Planning Commission

Regular Meeting Agenda

Frances Meaders Council Chambers
151 Willowbend Road
August 11, 2025 | 6:30 PM

SUBJECT: Landscape Plan Modification, Aventure Aviation, 108 International Drive

SUBJECT: Building Elevation Modifications, J Alexander's, 100 Market Place Blvd.

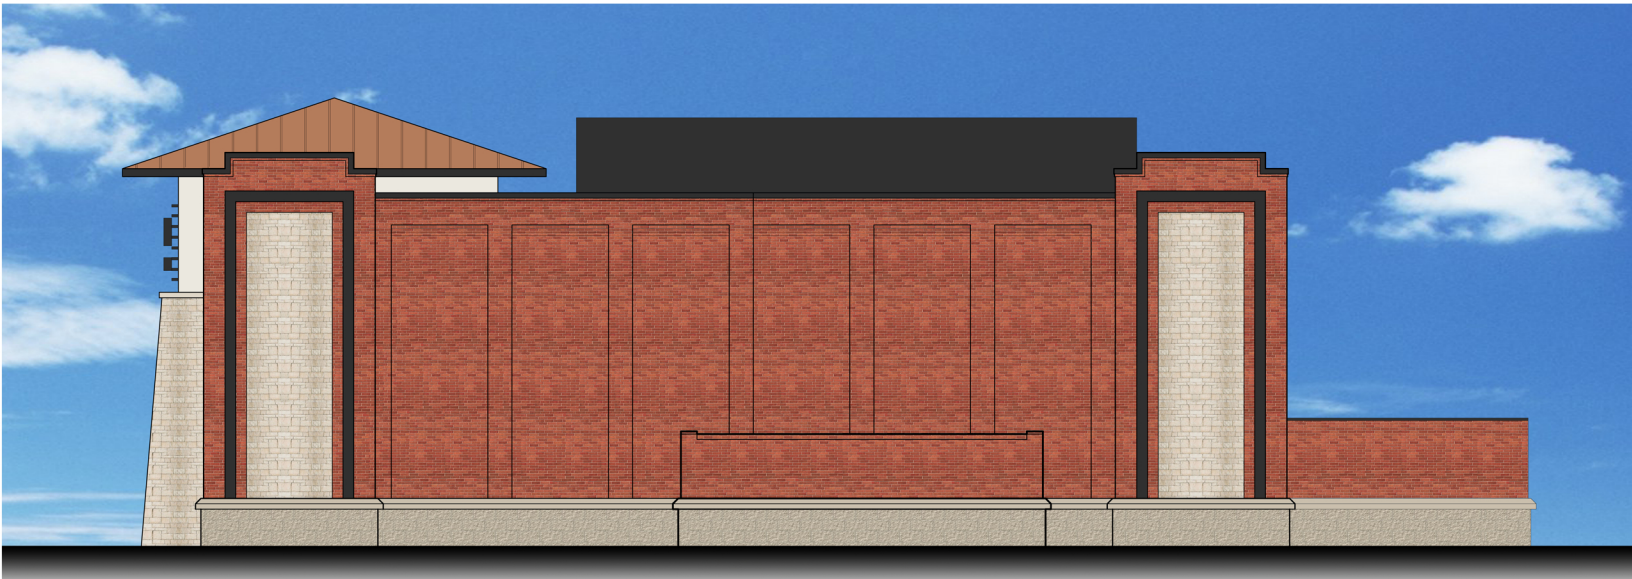
Commissioner Halverson and Senior Planner Lora Hooks met with the J. Alexander's team July 31, 2025. The team mentioned they were working on a new standard for architectural design for the brand and wanted to propose new modifications for the Peachtree City restaurant that would be similar to the new standards.

The new proposal for the building modifications maintains the entrance design originally proposed with EIFS and stone columns. However, rather than keeping the original brick color and adding stone at the building corners, the new design includes painting the brick Sherwin-Williams Alabaster, painting the stone-masonry base Sherwin-Williams Tricorn Black, and wrapping the support columns for the canopies with matte black metal.

Since EIFS is still proposed for the entrance feature, the front facade will be 77% primary materials (no change from the previous proposal). The remaining three facades will be 100% primary materials.

While the front facade materials fall short of the 80% requirement for primary materials by a small percentage, Staff feels the proposed building elevation modifications for 100 Market Place Blvd. meet the remaining requirements of the ordinances and development standards for Peachtree City.
